GLEN EIRA CITY COUNCIL

CARNEGIE CONCEPT PLAN CONSULTATION RESPONSES

Looking to the west of us

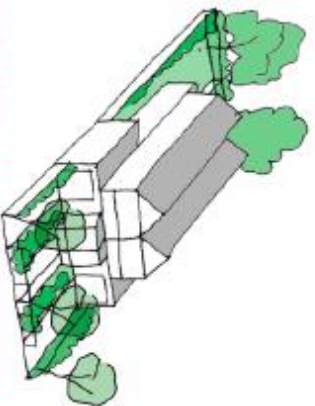
The houses next to us
are classified as Side-
by-side townhouse

Looking to our west

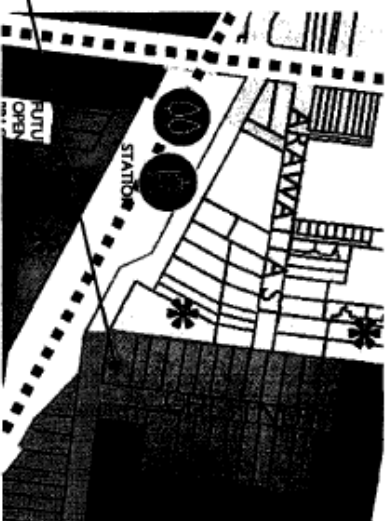
When looking west we see 1 of 3 1970's style units, which would be difficult to describe as heritage or character

Looking to the south of us

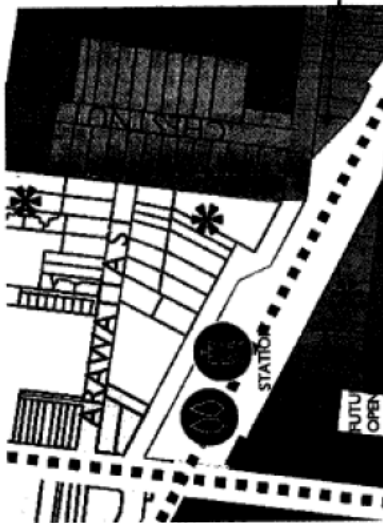
The house directly in front of us now sits on land classified as 'Terrace townhouse'. This house has been sold to the Level Crossing Removal Authority, as the house is significantly impacted by 'Skyrail'. Sitting behind this house will be an extensive car park.

Looking to our north

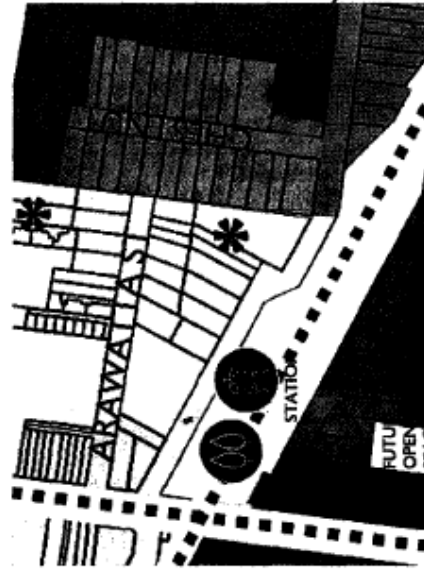
When looking north behind our property, there are 1970's two-story flats, again they would be difficult to describe as heritage / character
